## CLARIFICATIONS

22 August 2025

Erie County Department of Parks, Recreation & Forestry (“Parks”): Design and Engineer Report Services to Identify Coastal Erosion Solutions for Wendt Beach Park RFP # 2025-035VF

# Wendt Beach FEMA Flood Zones

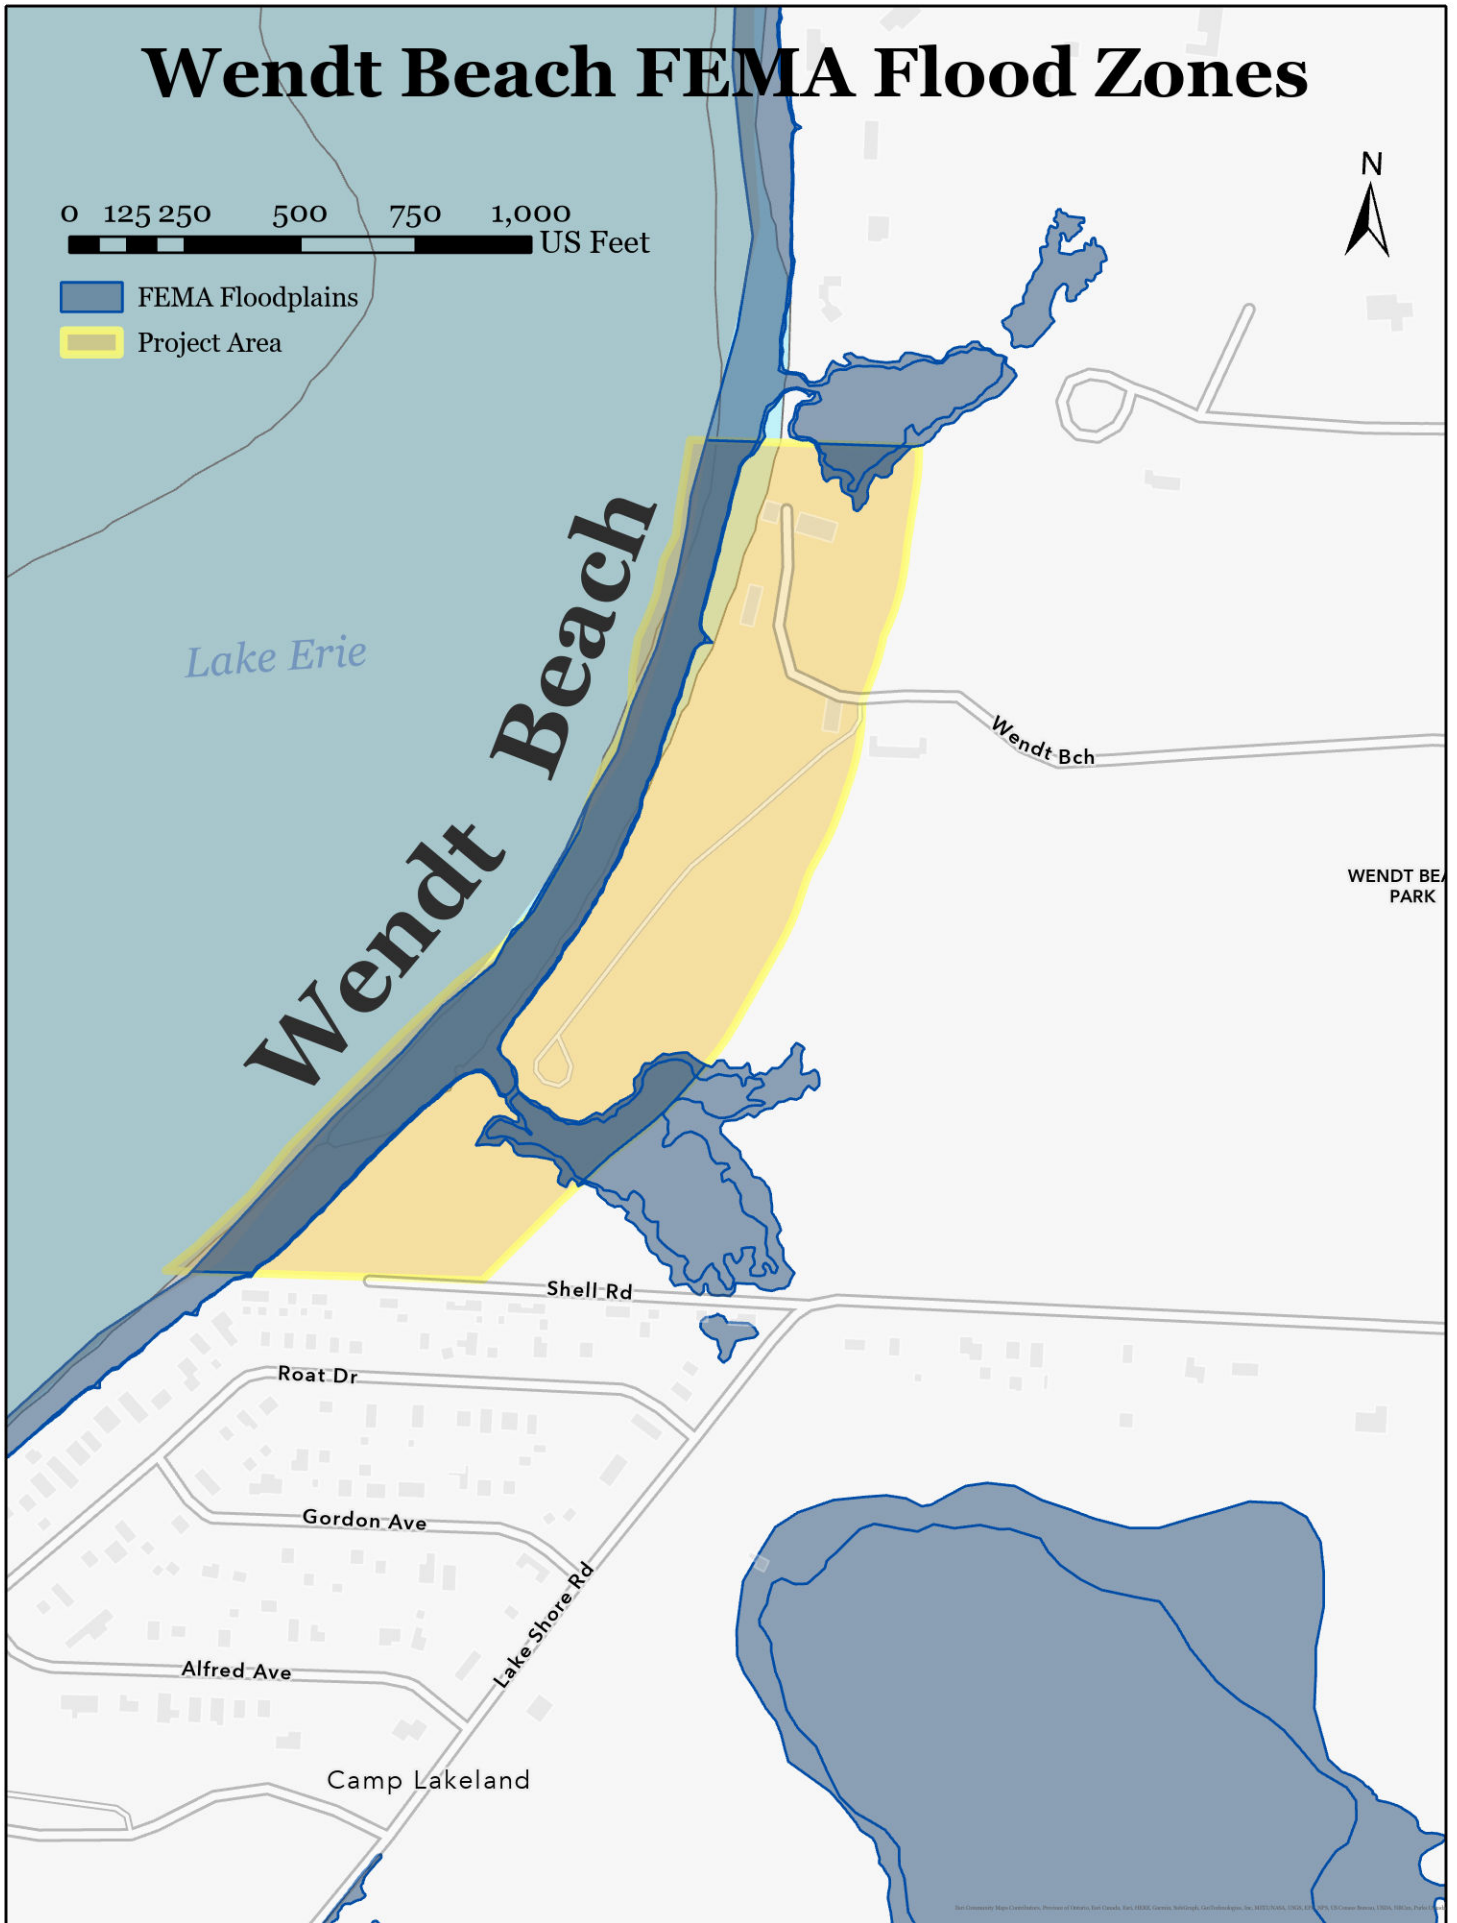
4. **Question:** Can you provide a map of the project area?

**Answer:** Yes, see Attachment C: “Wendt Beach Project Area and FEMA Map”.
